SWD-6

From: Patti Bonham [pbonham@prathomes.ca]
Sent: Tuesday, May 03, 2011 9:44 AM
To: 'Bruno Tidd'
Subject: SWD-6-Doane New Deal

SCHEDULE "A" MODEL AND FLOOR PLAN

Southwoods
1180sf
AD

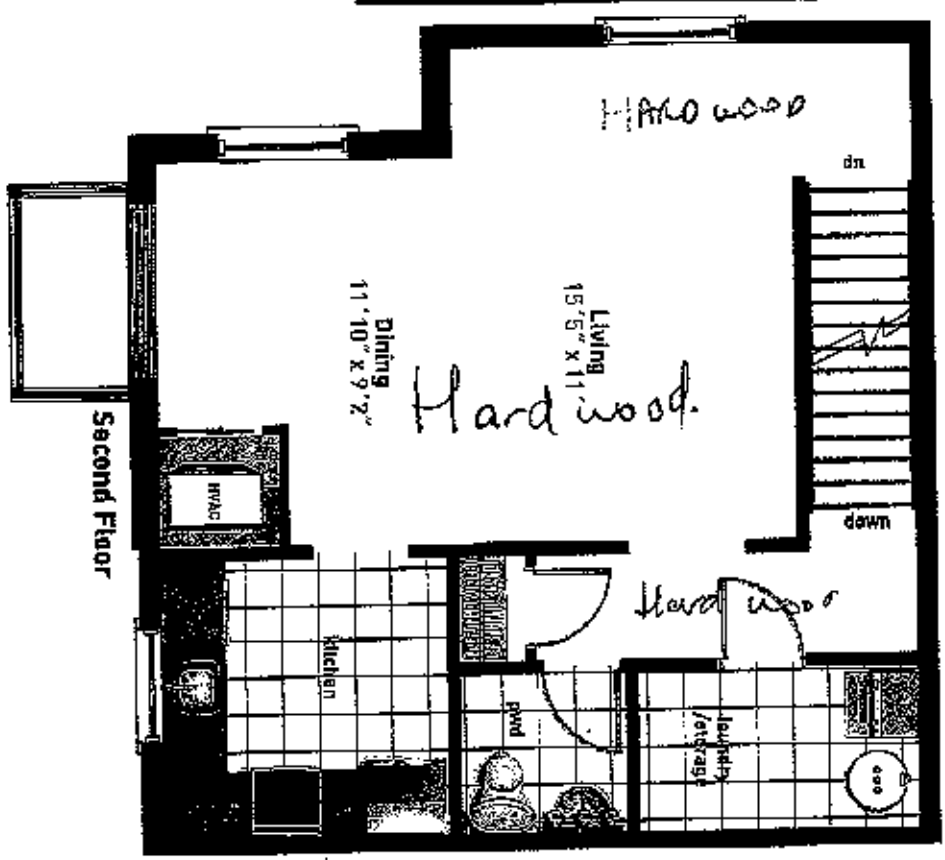
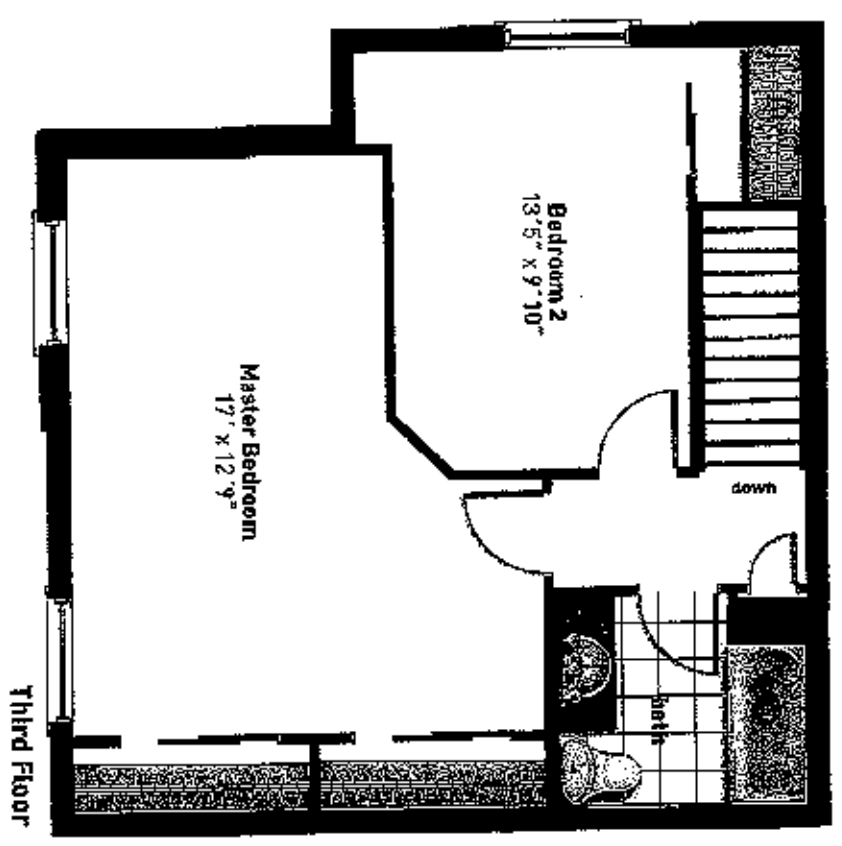
The work sheet and sched c both show hardwood flrg as shown in diag.
There is nothing written on the flr plan. Should there be?
